Our Ref: SK/8928/sk

22 March 2013

RE: PRESTONS SHOPPING CENTRE
TRAFFIC ENGINEERING SERVICES

Existing weekday morning peak hour traffic flows plus development traffic

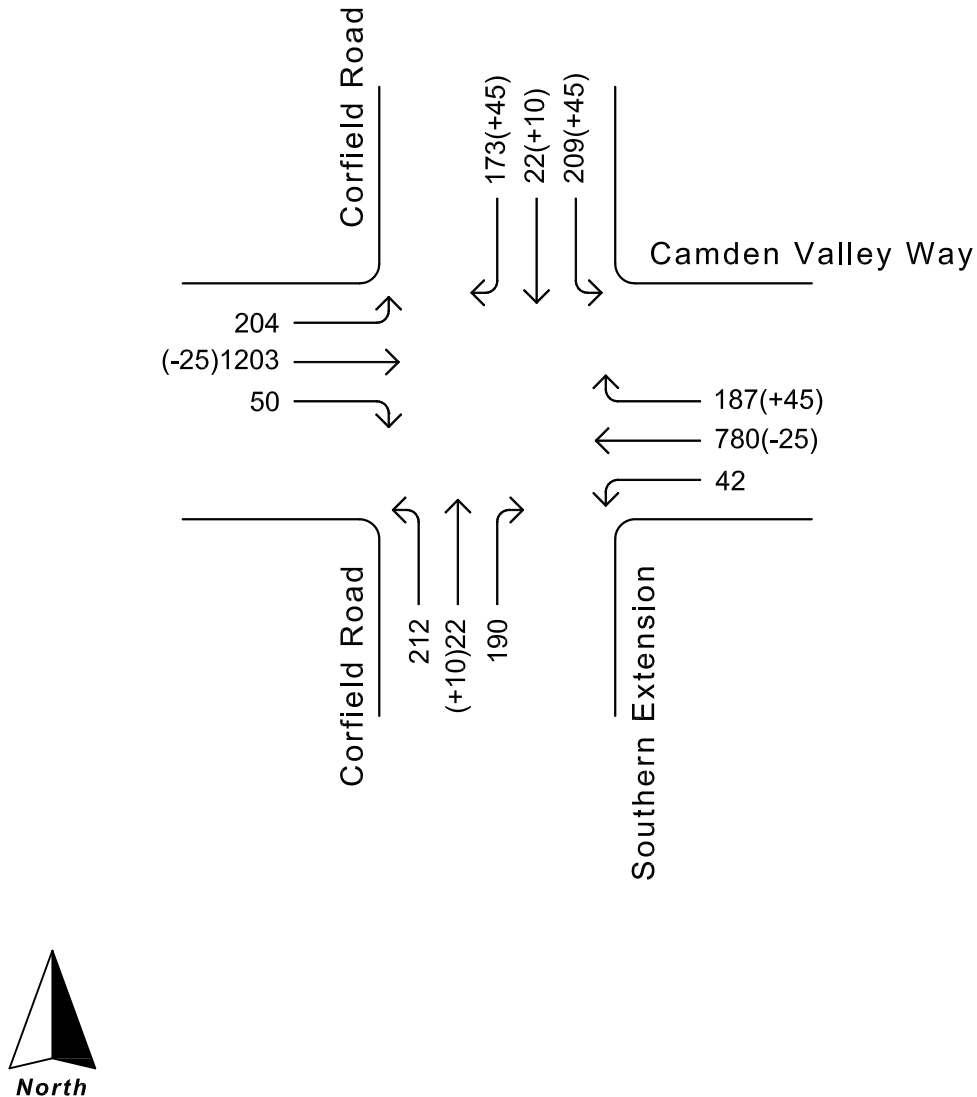
6. The existing morning and afternoon peak period traffic flows through the intersection, including traffic generated by the proposed future development to the south of Camden Valley Way (provided by Varga Traffic Planning and determined in consultation with RMS) and the proposed development traffic generated by the proposed shopping centre, are shown on Figures 1 and 2.

7. The intersection of Camden Valley Way/Corfield Road has been analysed with SIDRA as a four-way intersection for the forecast traffic flows and additional development traffic shown in Figures 1 and 2.

10. It can be seen from Table 1, that the four-way intersection with the existing traffic flows and the additional development traffic south of Camden Valley Way, will operate with average delays of 42.1 seconds per vehicle during the morning and 36.4 seconds per vehicle during the afternoon peak periods. This represents levels of service D and C respectively, which are satisfactory levels of intersection operation.

11. The SIDRA analysis found that with the subject development traffic the intersection would operate with average delays of 44.2 seconds per vehicle during the morning and 38.2 seconds per vehicle during the afternoon peak periods. This represents levels of service D and C respectively, which are satisfactory levels of intersection operation.
